From: Mr James Maclachlan
140 Georges River Road
Jannali 2226
7th May 2012

To: The Director General
New South Wales Department of Planning

Re: Proposed Amended Sharks Development

Annexure A Sheet 10 of 12

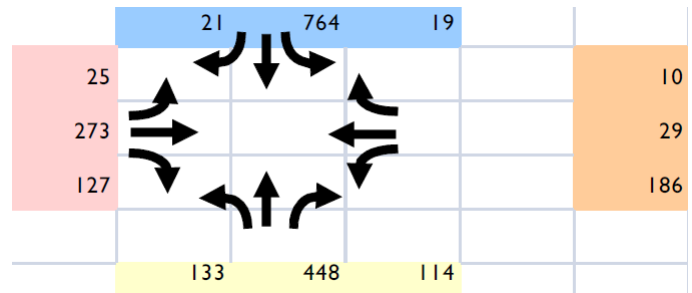
For westbound traffic on Captain Cook Drive between these two intersections, these diagrams in the Traffic Study report indicate that:

- **19 vph** from Captain Cook Drive east of the intersection with Elouera Rd, plus **17 vph** turning left from Elouera Rd, totalling **36 vph**, enter Captain Cook Drive westbound,

- **14 + 659 + 9 = 682 vph** enter the intersection with Woollooware Rd,

which is a discrepancy of **646 vph**, a significantly extreme anomaly.

Much of this extreme anomaly appears to derive from the **19 vph** and **17 vph** intersection-entering values at the Captain Cook Drive/ Elouera Rd intersection that are far too low and should have been questioned at the outset and the monitoring redone. However these obviously anomalous readings have been included in the report such that the integrity of the whole traffic study becomes dubious.

Annexure A Sheet 7 of 12

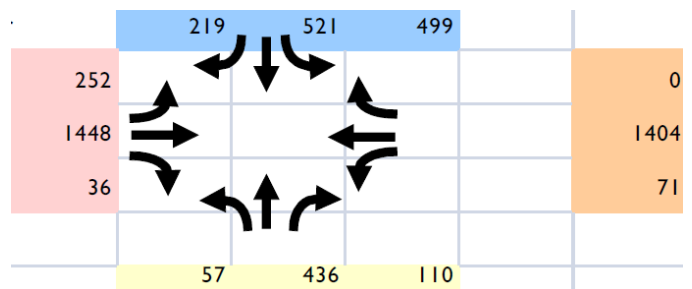
For southbound traffic Gannon's Rd on between these two intersections, these diagrams in the Traffic Study report indicate that:

- **127 vph** from Denman Ave west of the intersection of Gannon's Rd with Denman Ave, plus **764 vph** travelling straight ahead from north of this intersection, plus **186 vph** turning left from Denman Ave, totalling **1077 vph**, entering Gannon's Rd southbound,

- **219 + 521 + 499 = 1239 vph** enter the intersection with The Kingsway,

which is a discrepancy of **162 vph**, much less than the aforementioned extreme anomaly but still significant.

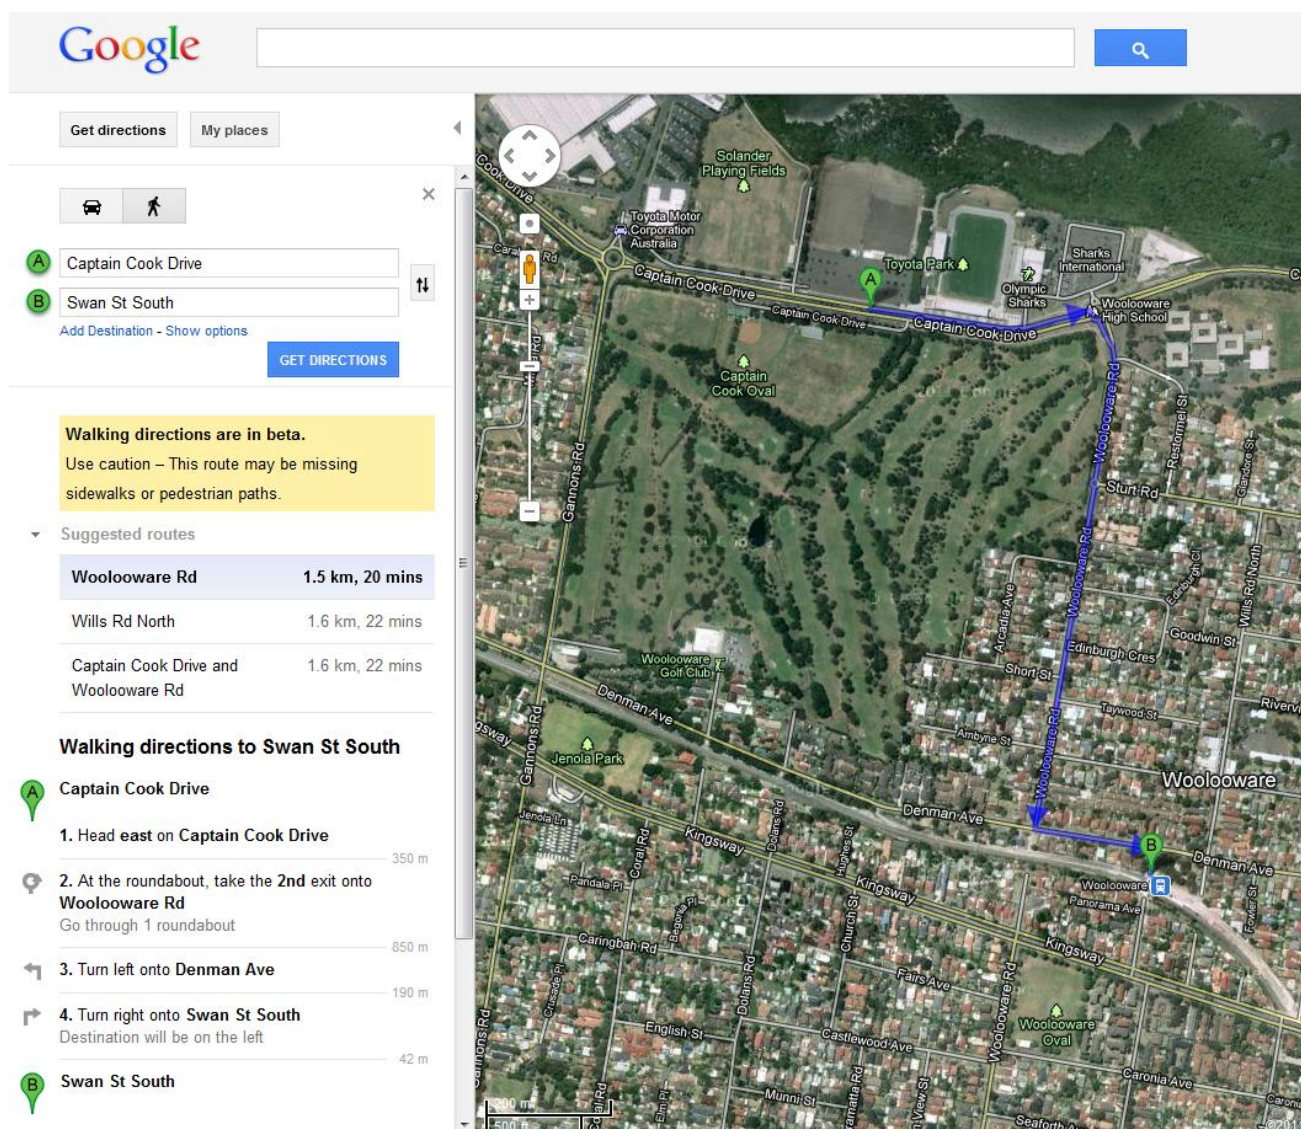
Although the figure of 1 km is quoted often, it is not applicable to the proposed residential part of the development. Google maps indicate that the walking distance is 1.5 km from the location of the proposed entrance to the residential development, with a walking time of 20 minutes. The 15 minutes claimed would be a very brisk walk of 6km/h which is possible but the average would be 5 km/h or less.

Note that although the destination is shown as “Swan St South”, it (Point B) is nevertheless right on top of the railway Station as indicated above

Therefore the development site does not meet this principal criterion for a growth centre.

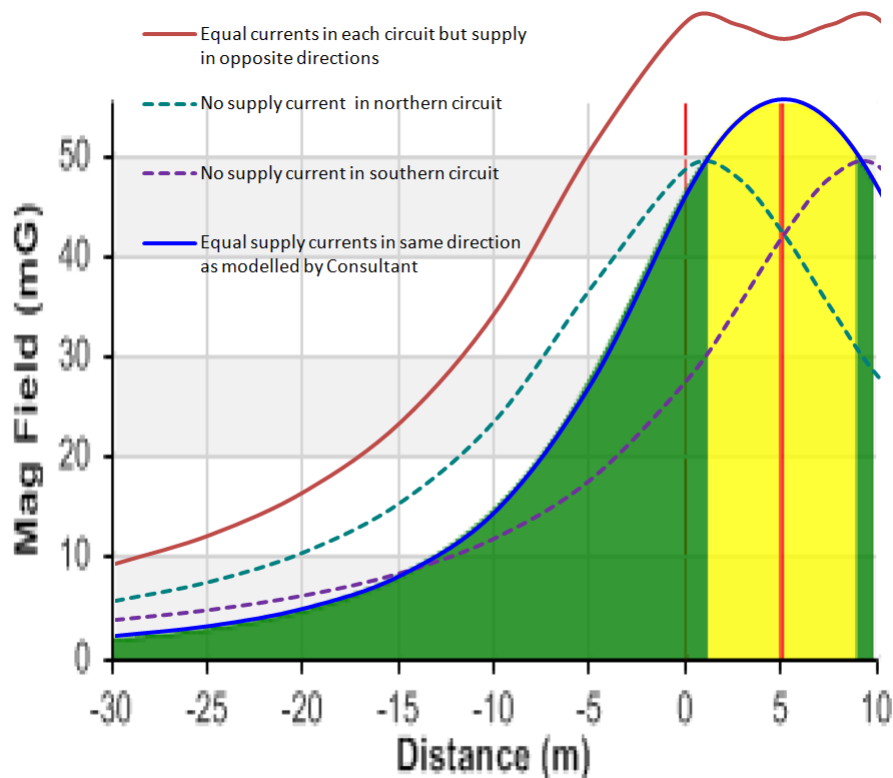
However the diagram in Section page 2 *(Requires colour to see. Middle yellow wires are difficult to see)*

shows that the top and bottom phases of one side/circuit have been reversed.

My enquiries to Ausgrid revealed that the configuration is “reverse phase”, which corresponds to the consultant’s calculation such that the consultant’s description is wrong. However, the spokesman said that the two circuits are separate from each other and their currents will not be exactly the same. He said that after a new supply from la Perouse is installed that that the currents could occasionally be in opposite directions. He said he was unable to give any data for how much the variations could be and how often differing operational modes may occur.

The consultant’s calculation with the two circuits supplying on the same direction with exactly the same current in each is an idealised simplification that would underestimate the magnetic field because of the magnetic fields are significantly reduced by the opposing phase currents. In the extreme case of opposing supply in each circuit, the calculated magnetic field at a distance of 30 m and 1m would be 4½ times as large for as that for the idealised equal supply in same direction scenario calculated by the consultant, shown on following graph, showing also the increase in the magnetic field when each circuit is shut down so that the magnetic field balancing is lost.

Fig.5 Magnetic field profiles across the power line easement for different heights above the natural ground and for the present electrical load of 445 A per circuit.

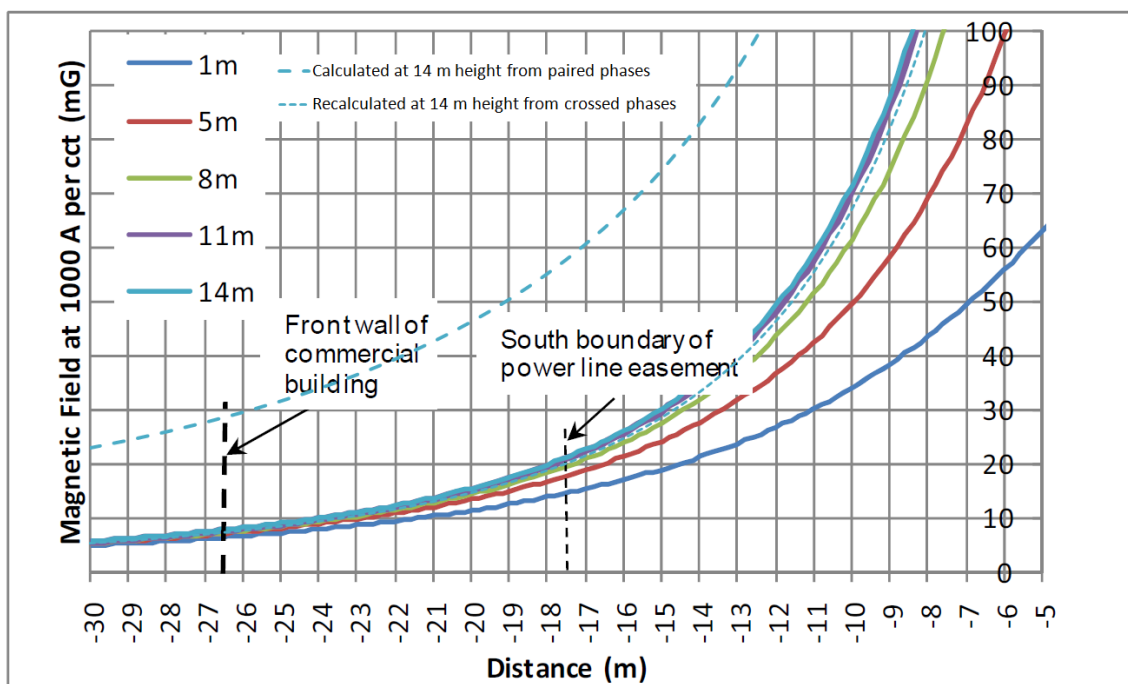
Note that the Figure 5 annotation is a second instance of a preceding similar figure 5 in the Consultant's Report. Whereas the Consultant's plotted lines are consistent with the 1000 A calculation (albeit erroneously for swapped phases), the title of the chart

erroneously refers to 445A case. The reference to "paired phases" corresponds to the worst case scenario of opposed supply with reverse phase operation. The other two cases of zero current on each circuit have not been calculated.

Fig.1 Electric field profiles at various distances above ground

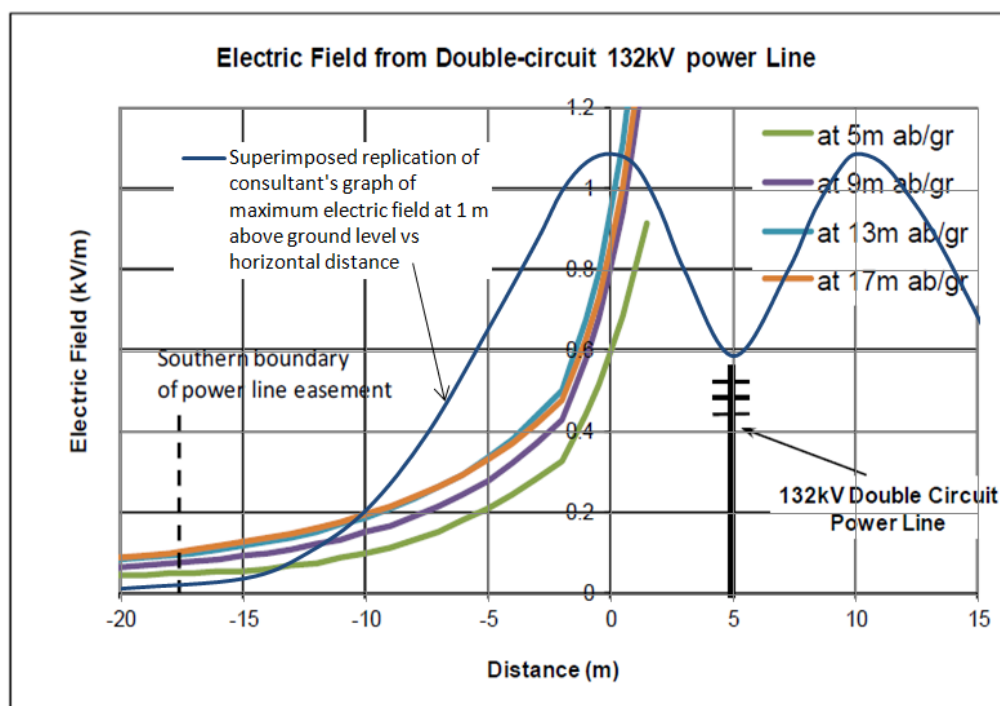
In their brief 1¼ page response to Council concerns, Magshield has included a graph of the electric field at varying heights. Since they did not include the original curve for the standard 1 m exposure, I have overlayed a replica of this curve onto their new graph. This clearly reveals an error where the Consultant has shown electric fields nearer to the pylons at all heights would be less than those calculated for 1 metre above ground level.

It is impossible that the electric field at heights closer to the wires can be always be less than that at 1 m height, at least outside the cluster of conductors. The sharp bend in the Consultant's curves at distance of minus two metres increases the doubt about the Consultant's new graph and the values at distance.

Fig.1 Electric field profiles at various distances above ground

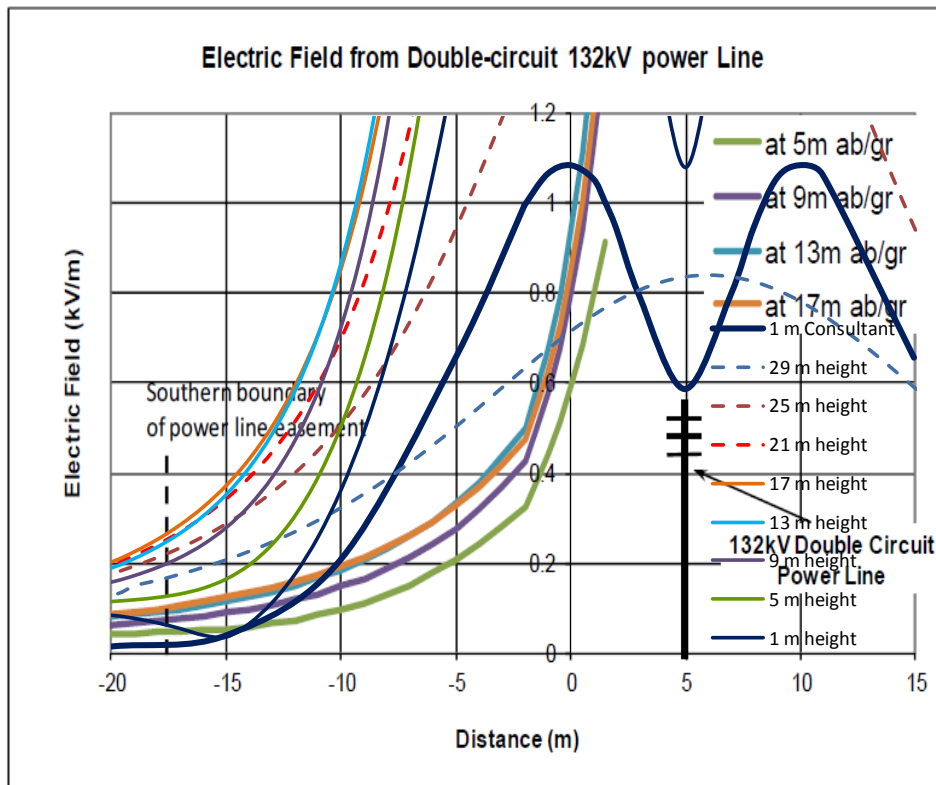
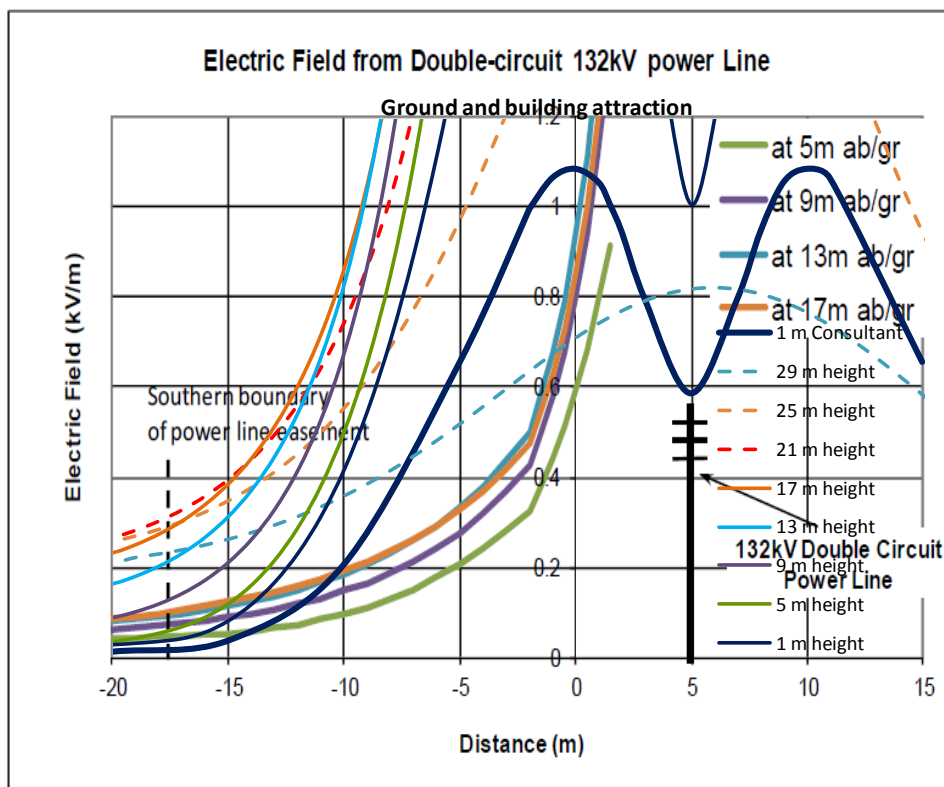
My calculations indicate about 100 V/m intensity at 25m horizontal distance if electrostatic building attraction is ignored. Allowing for building attraction would significantly increase the field, up to double, according to my calculation. This is 5 metres further left of the chart and is where I assumed to building to be, and where the ratio is greater than apparent at the edge of the graph at "-20 m" distance.

For comparison I have overlaid my curves on the consultant's graph to indicate the inconsistencies. My calculations are in thinner line to match the colours used by the consultant for each height up to 17 m. Values for heights above 17m are shown dashed.
